ADDENDUM NO. 1 ELEMENTARY ADDITION TO SUMTER CENTRAL HIGH SCHOOL

Architect Job No. 24-38 July 24, 2024 DCM # 20240619

PROJECT:	PROJECT NO.	REFERENCE:
ELEMENTARY ADDITION TO SUMTER CENTRAL HIGH SCHOOL	24-38	ADDENDUM NO. 1
ARCHITECTURAL ADDENDUM DRAWING	DATE:	SHEET NO.
ANCHITECTORAL ADDENDOW DRAWING	7/10/2024	ADD 1

1 POWER AND VOICE/DATA - FLOOR PLAN - PART A

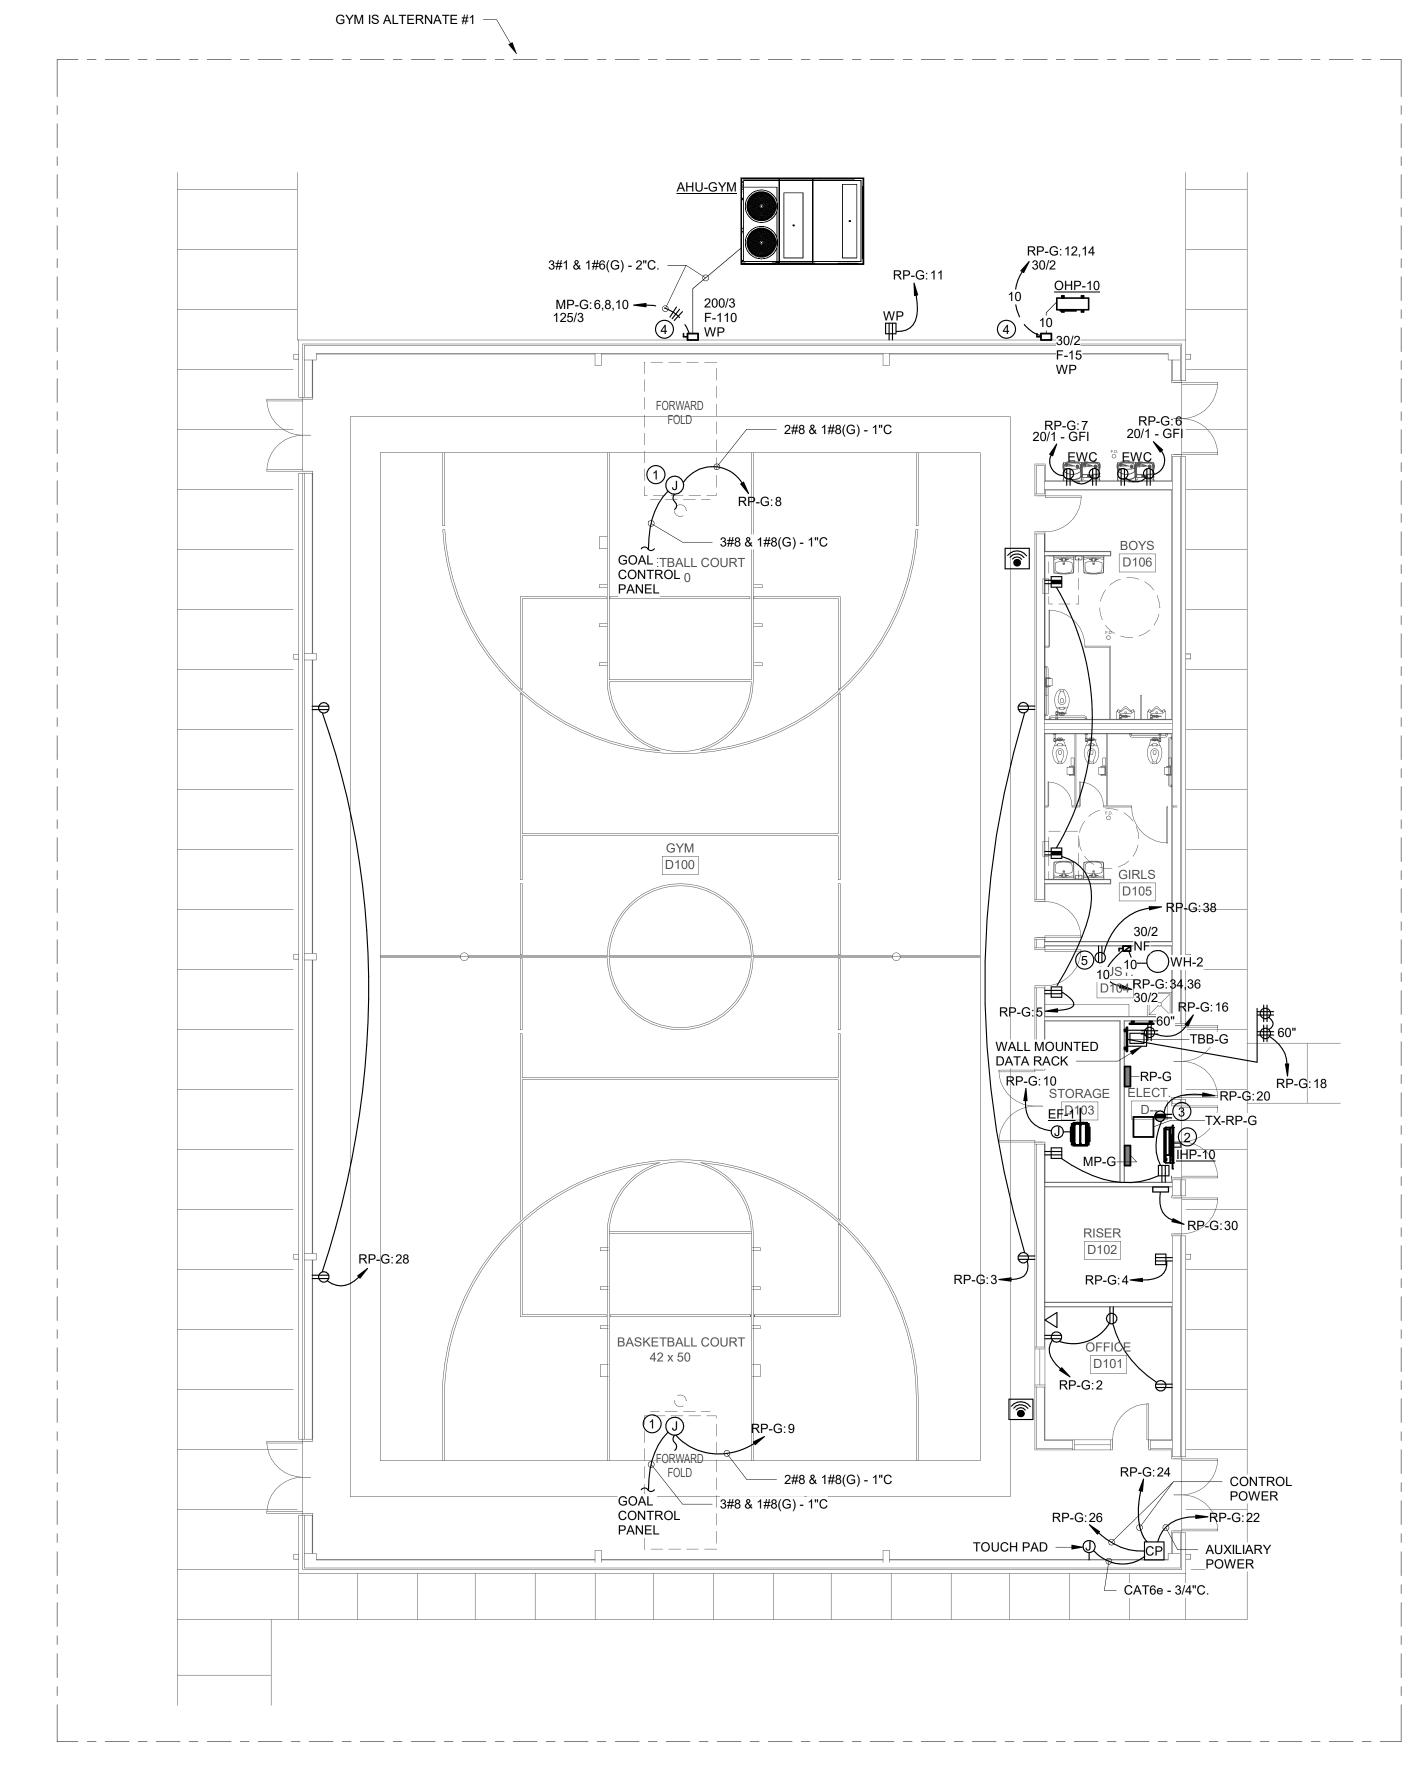
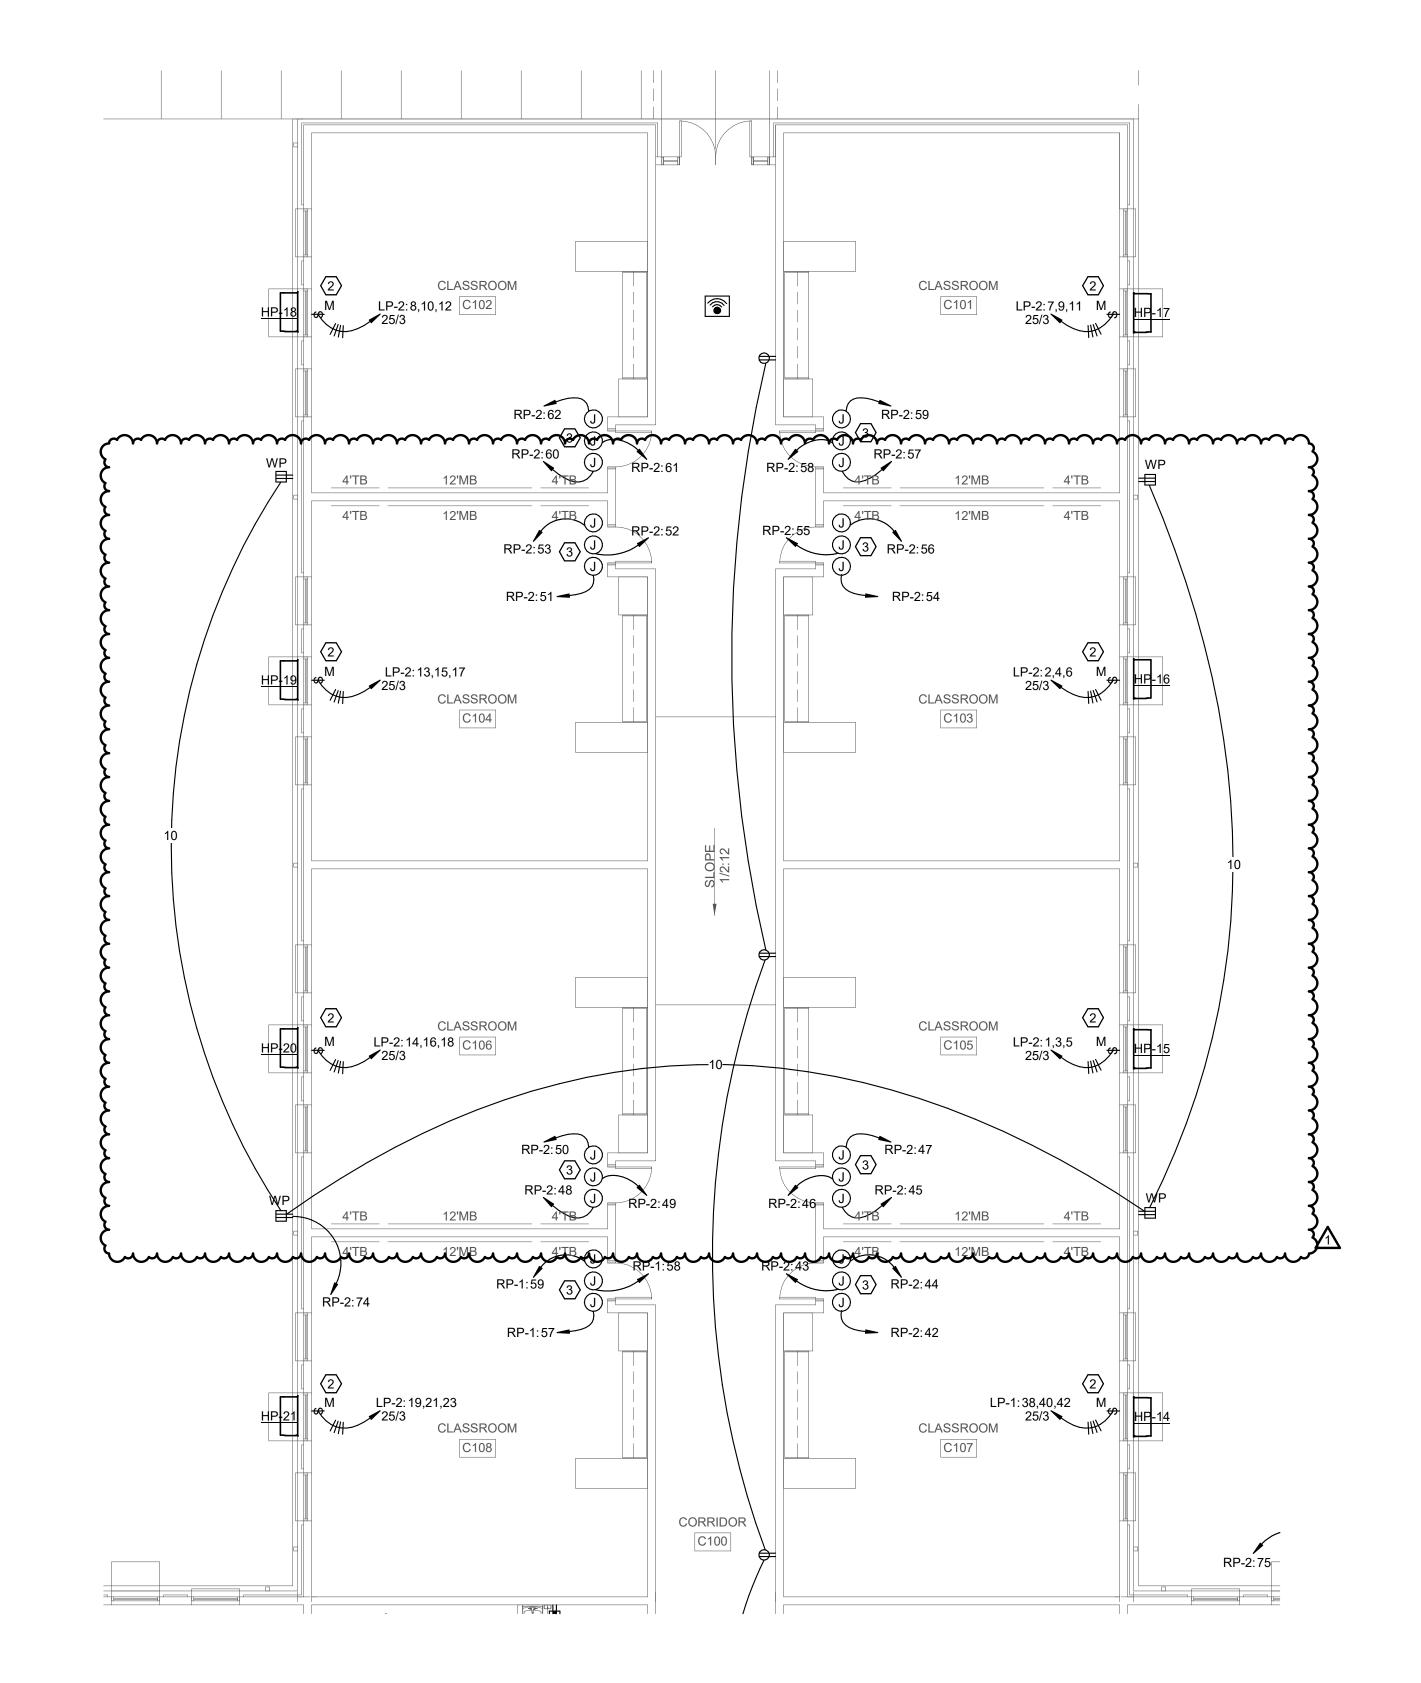
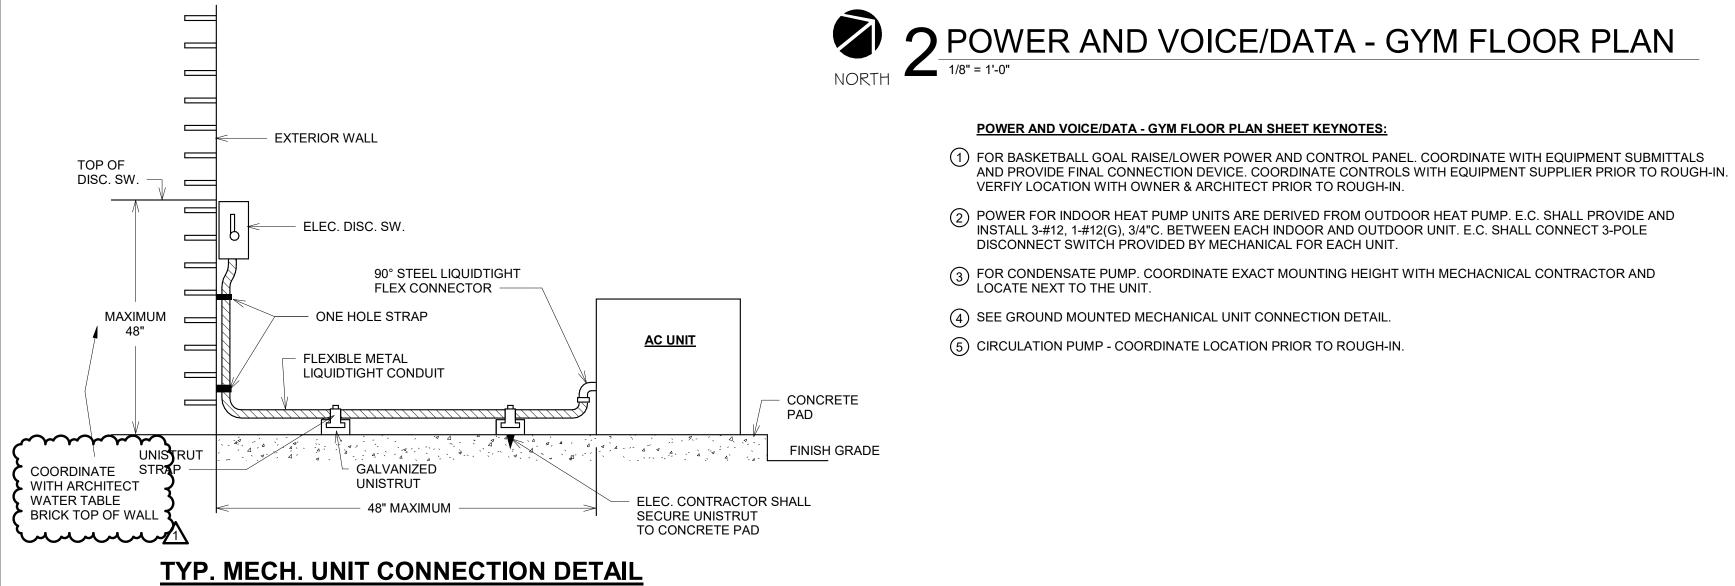
- 35. See attached Sheet **E3.0** for revisions to Power and Voice/Data Floor Plan Part A. Revised to include GFCI receptacles within 25' of HP units serving classrooms.

E4.0

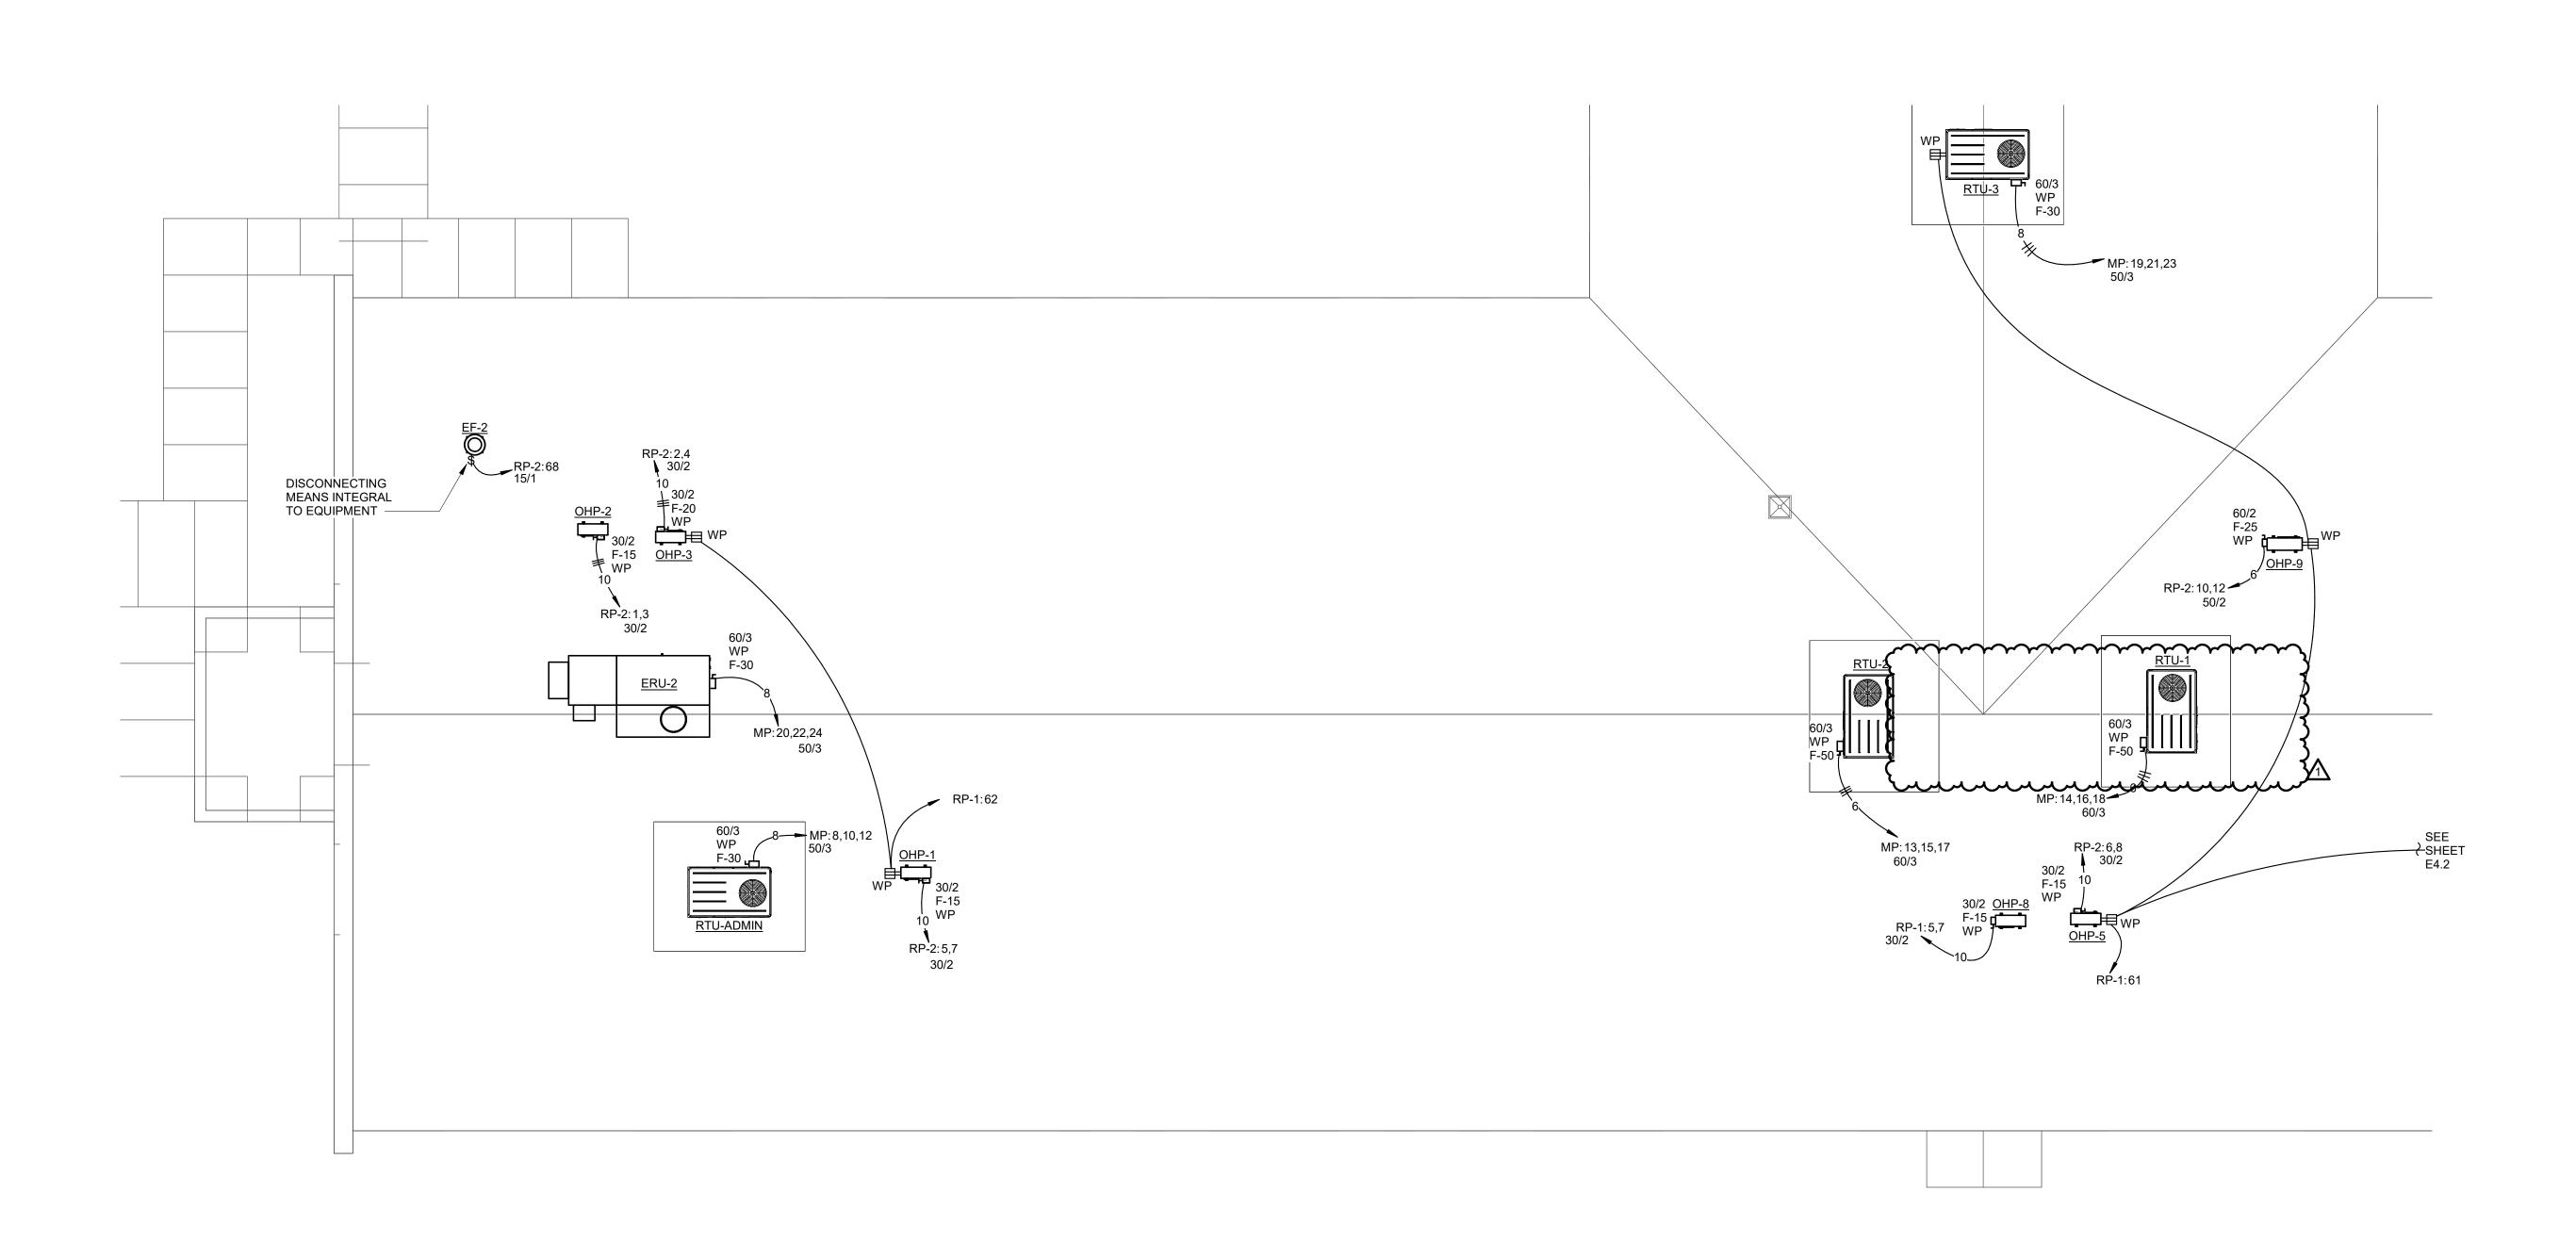
- 38. See attached Sheet **E4.0** for revisions to Electrical Roof Plan Part A.
- 39. See attached Sheet **E4.1** for revisions to Electrical Roof Plan Part B.
